NEC® Code-Making Panel 12 First Draft Meeting Agenda

January 21 - 23, 2024

NEC® Code-Making Panel 12 Second Draft Chair Report

<u>File Name</u>	<u>Description</u>	<u>Approved</u>
376.22_A_.jpg	An example of how absurd 50% fill would be.

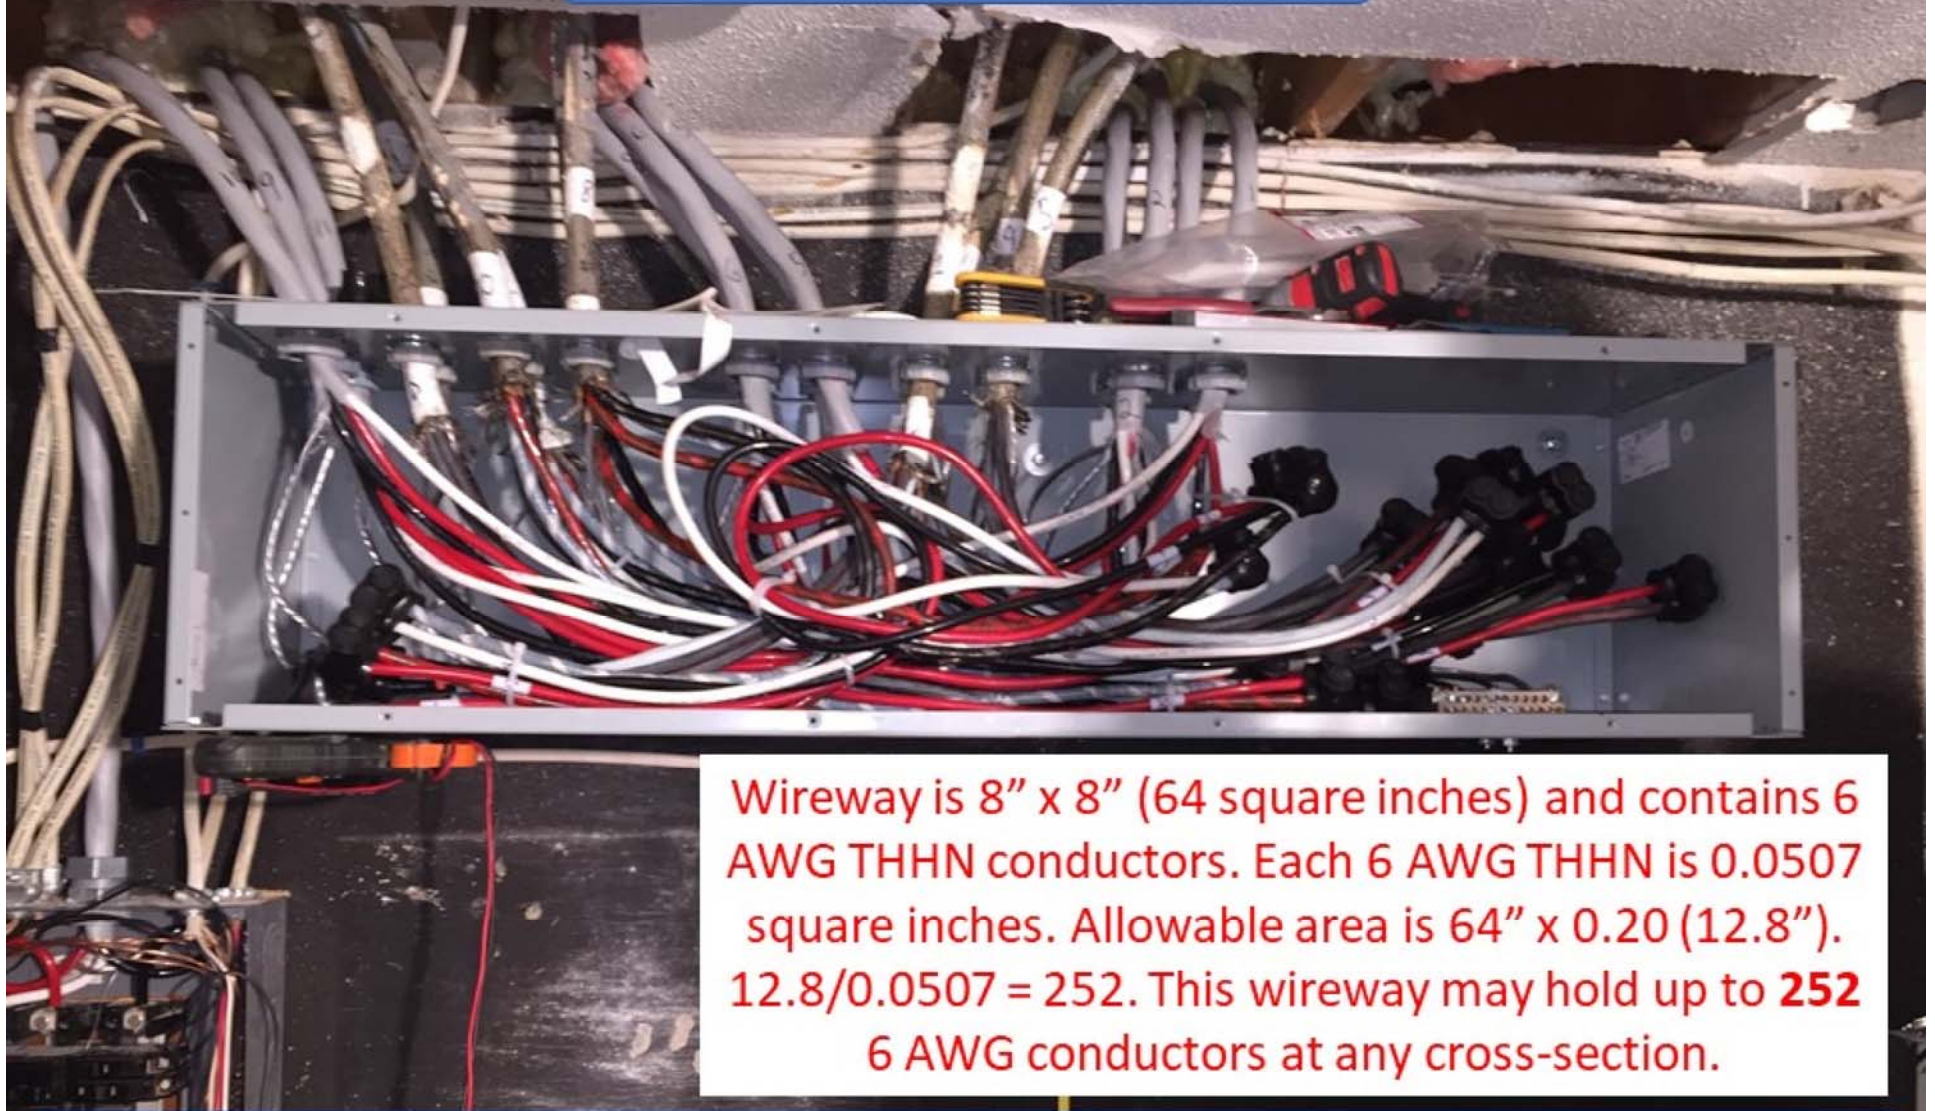
Filling a wireway to 50% would result in a wireway that could not possibly have a cover on it. Please do the math. Everything in this section is already (or better) addressed in 376.22 and 376.30. See 90.3 and 4.1.1 of the Style Manual.

Public Input No. 2445-NFPA 70-2023 [Section No. 620.62]

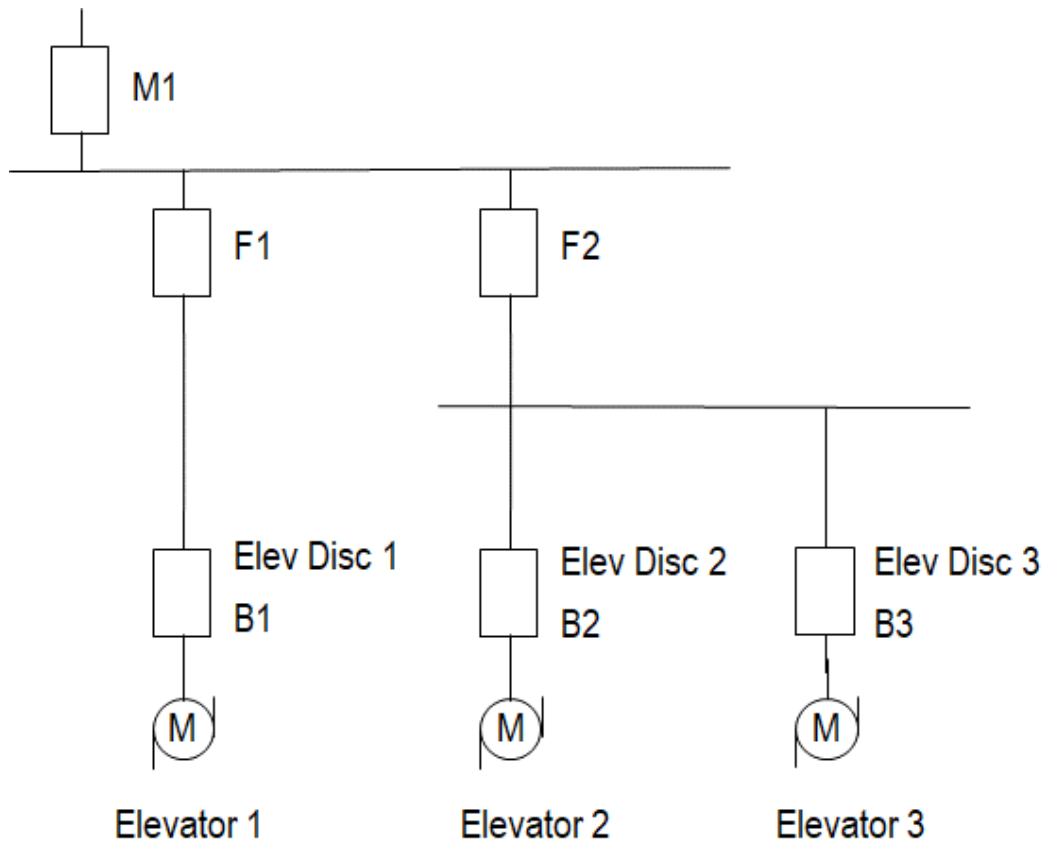
This public input clarifies that selective coordination needs to consider all overcurrent protective devices supplying elevators to assure an overcurrent condition will not result in loss of power to another elevator. An informational note and figure is added similar to that in NEC 700.32, 701.32 and 708.54.

620.62 Selective Coordination.

Where more than one driving machine ~~disconnecting means~~ is supplied by the same source, the overcurrent protective devices in ~~each disconnecting means~~ (OCPDs) supplying the driving machines shall be selectively coordinated with any other supply-side overcurrent protective devices OCPDs .

Informational Note: See Informational Note Figure 620.62 for an example of how OCPDs supplying elevators selectively coordinate with all supply-side OCPDs.
